Variance Report

Variance No.: <u>LMS-FER-S03496-7.0-02</u>	Significant: <input checked="" type="checkbox"/> Yes <input type="checkbox"/> No
Document No.: <u>S03496-7.0</u>	Page: <u>1</u> of <u>2</u>
Document Title: <u>Comprehensive Legacy Management and Institutional Controls Plan (LMICP), Rev. 7.0</u>	Date: <u>5/27/2014</u>

Variance LMS-FER S03496-7.0-02 (Continued):

U.S. DEPARTMENT OF ENERGY GRAND ARCHAION, COLORADO	Work Performed by The S.M. Stoller Corporation <small>Under DOE Contract No. ES-AW01-07-ET-00000</small>
Fernald Preserve Aquifer Remedy within the Area of Concern	
DATE PREPARED: May 28, 2014	FILENAME: S1166302

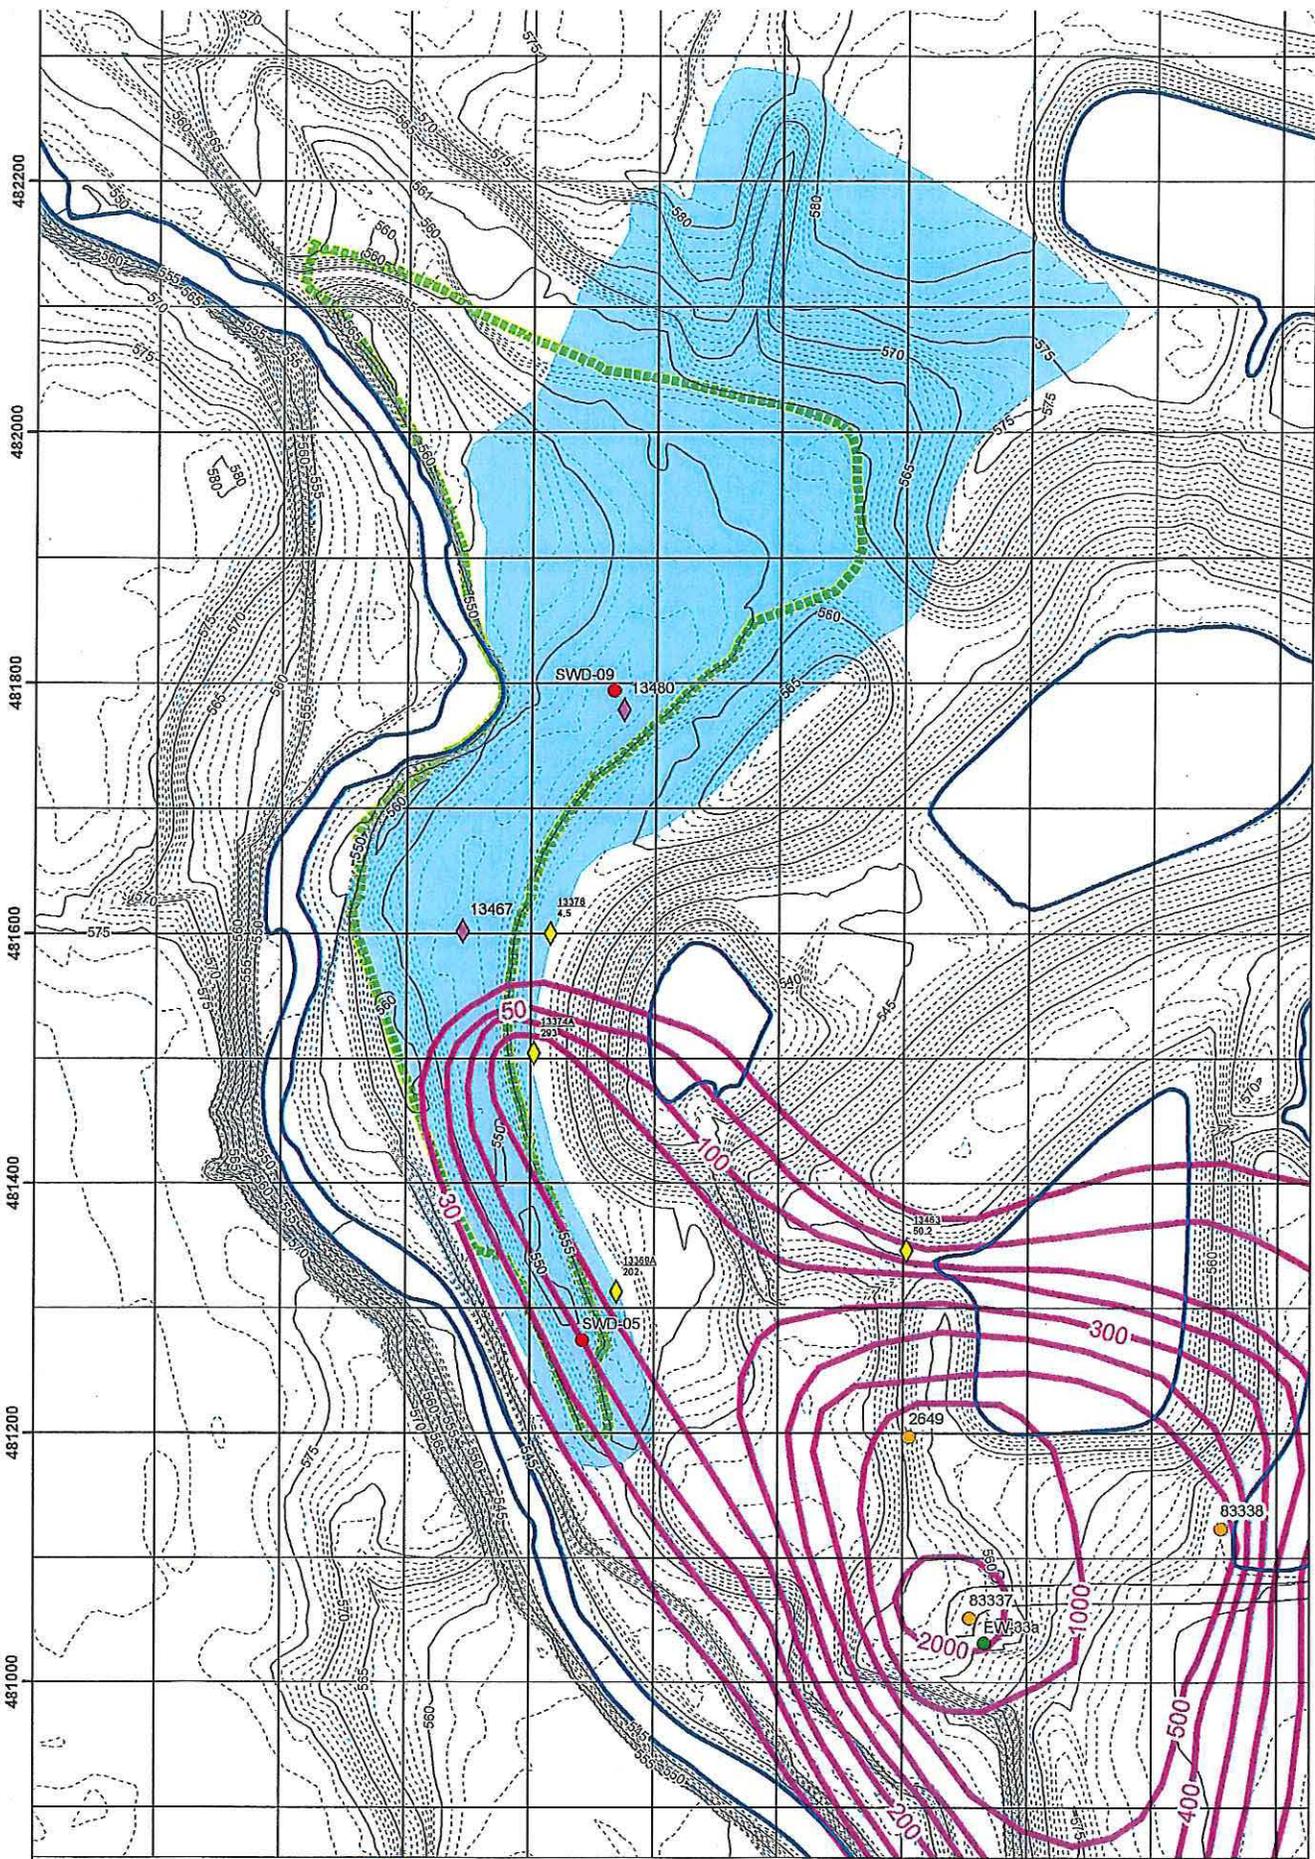
Variance: Continuous soil cores will be collected at all Geoprobe locations planned within the watershed of a closed basin that is located west of Former Waste Pit 3 (referred to as the Swale Area). Soil descriptions (using Unified Soil Classification Protocols) will be completed for the purpose of refining subsurface soil interpretations. The attached map shows the location of the watershed area and two Geoprobe locations currently planned in the area (Location 13467 and 13480).
